HISTORIC AND DESIGN REVIEW COMMISSION

HDRC CASE NO: 2017-490
ADDRESS: 820 HAYS ST
LEGAL DESCRIPTION: NCB 1656 BLK D LOT 10
ZONING: R-5 H
CITY COUNCIL DIST.: 2
DISTRICT: Dignowity Hill Historic District
APPLICANT: Alanzo Alston/Sol Studio Architects
OWNER: Cynda Reznicek
TYPE OF WORK: Construction of a single family residential structure
REQUEST:

The applicant is requesting a Certificate of Appropriateness for approval to:

SHEET
Dwg 4
4 OF 4 SHEETS

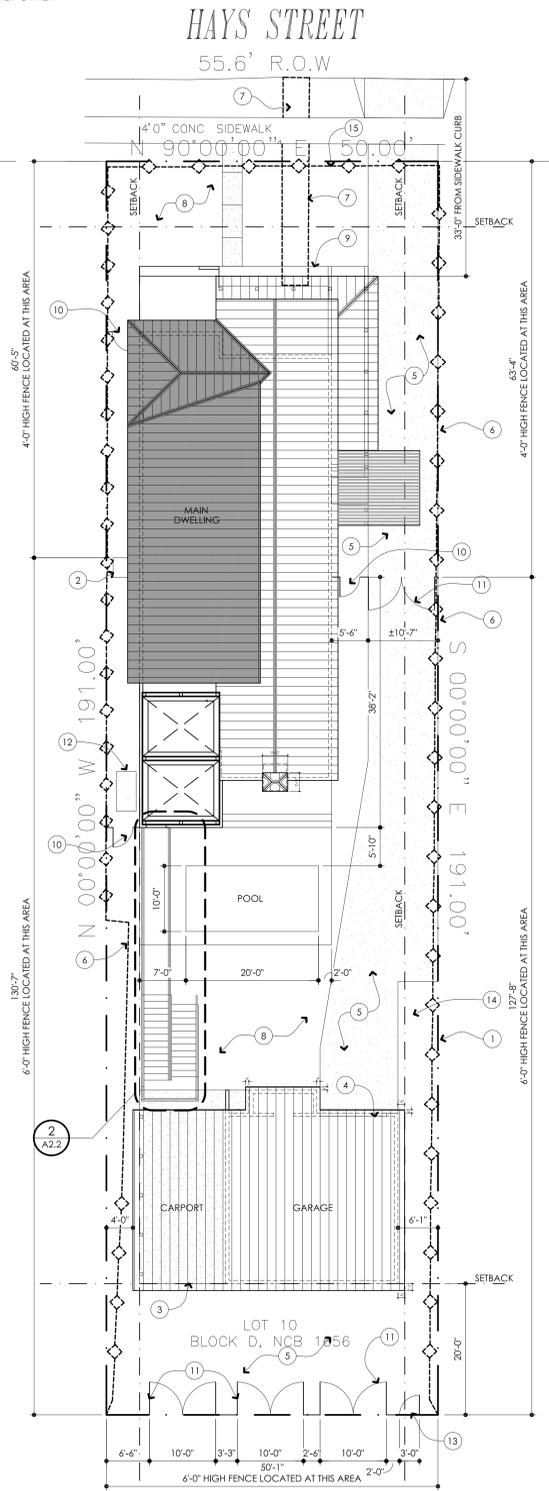
- iii. That the applicant eliminate the proposed front porch corten planter, bronze colored roof and cement plaster finish from the proposed materials as noted in finding o.

Upon the ARC meeting dated April 11, 2017 we were encouraged to find examples of proposed materials currently in the neighborhood fabric for response to this comment. In addition, we were encouraged to consider the corten steel planter as a take on a porch railing and re-work it to introduce a shadow pattern emulating railing balusters. The attached exhibit (Drawing 2) indicates the corten steel to be modified to give a shadow line and the attached exhibit (Drawing 3 and 4) indicates examples of differential roof types and corten steel in the neighborhood that we are using as visual cues in the design.

Although we provided Drawing 2 to modify the corten steel planter the Historic Design and Review Committee understood the overall concept, materiality, decision making in the overall design. The committee then approved the design as originally submitted per the April 19th review meeting. With that, approval the corten

steel planter design remained intact, the cement plaster finish selection remained intact and the differential roof material remain intact.

SHEET
A4.0

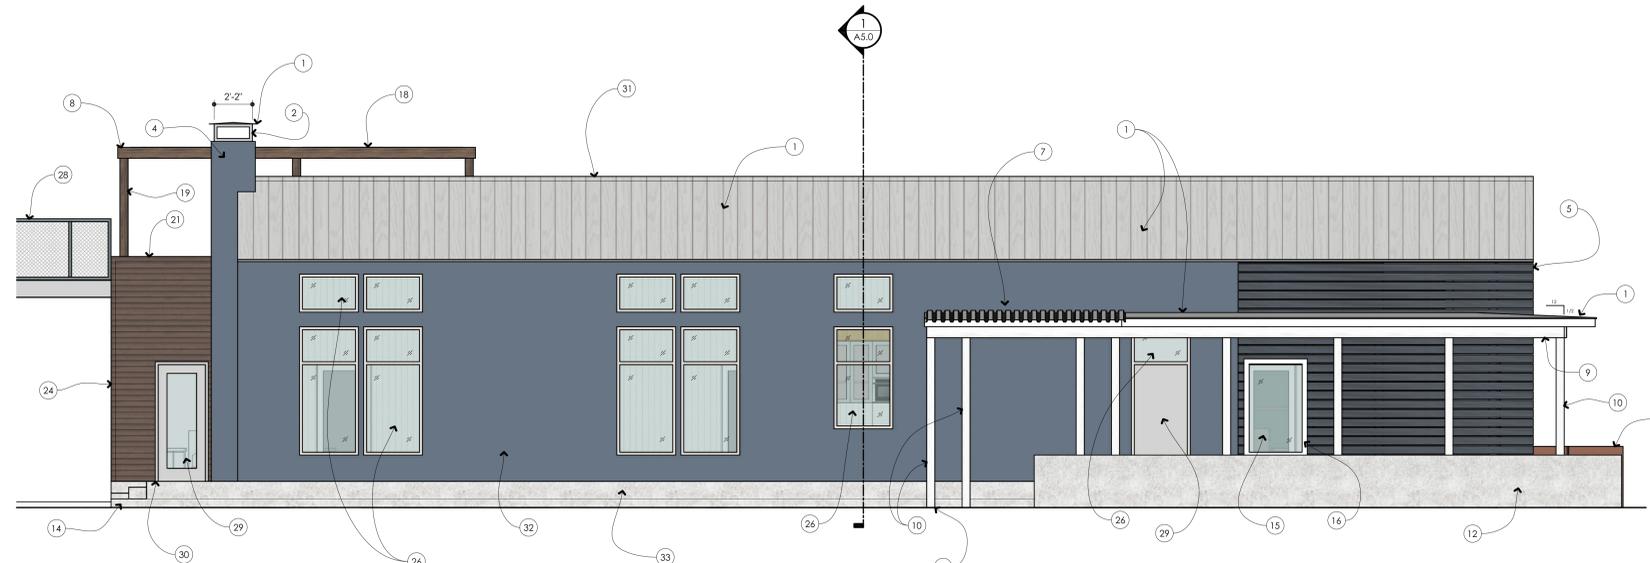
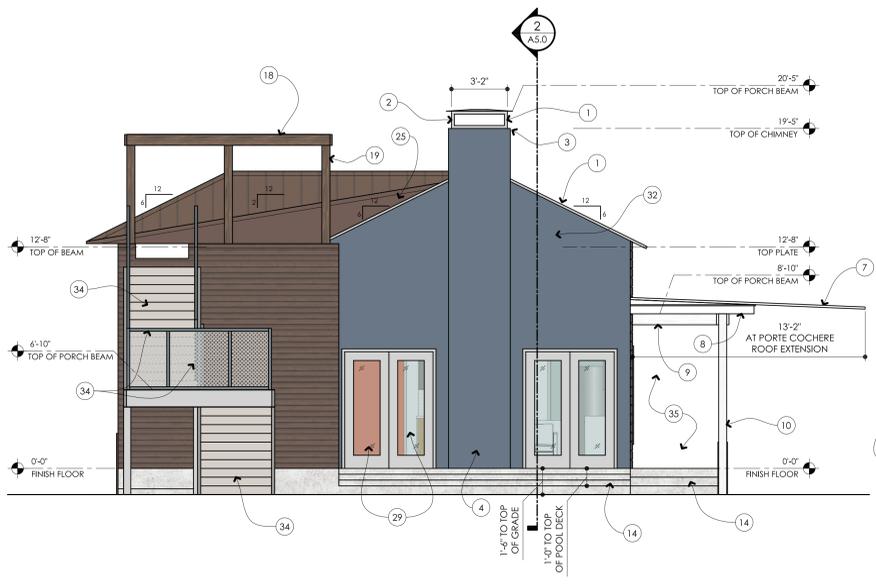
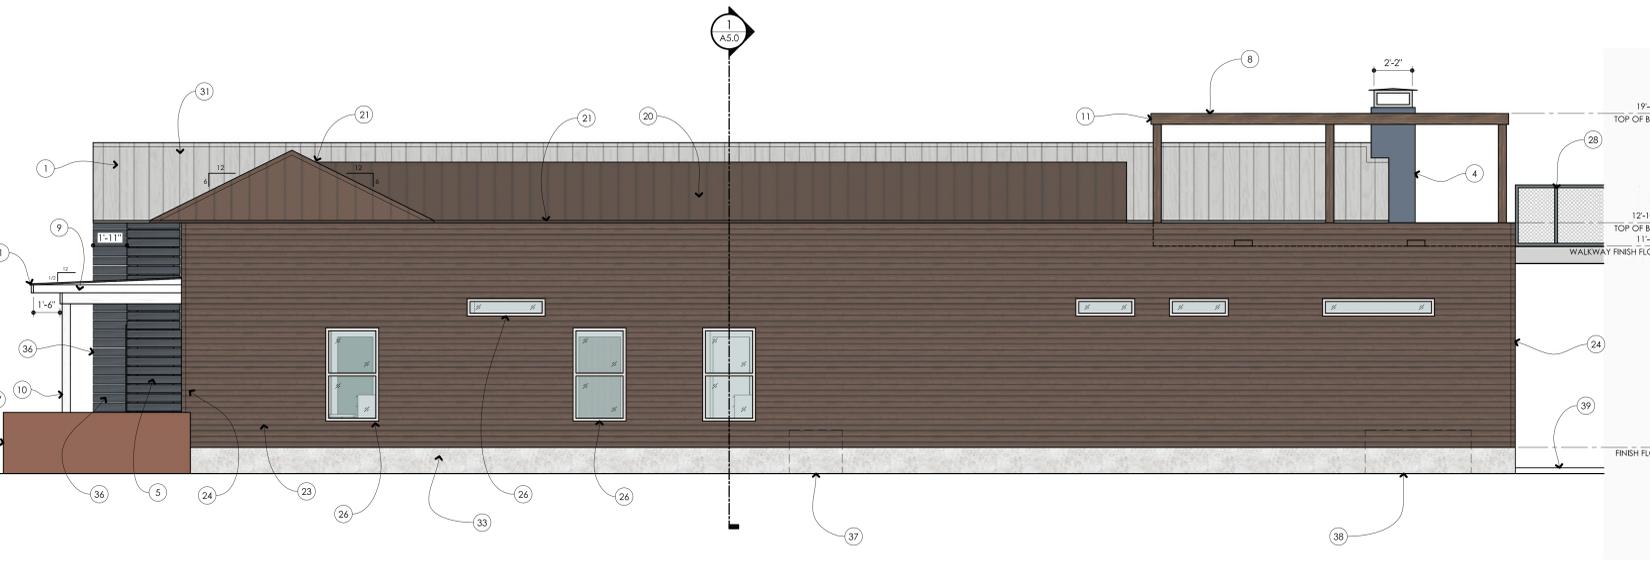
- s. PLANTER BOX – The applicant has proposed to locate a corten planter box on the front façade of the proposed new construction. This material and the location of a planter box on the front façade of a structure to be located in a historic district is not appropriate.

- ii. That the applicant eliminate the proposed front porch corten planter, bronze colored roof and cement plaster finish from the proposed materials as noted in finding m and s.

Concur - The Construction Documents currently reflect a standing seam roof with 1" ribs and are spaced at 18" o.c. max. however the differential roof finishes remain due to response to item iii.
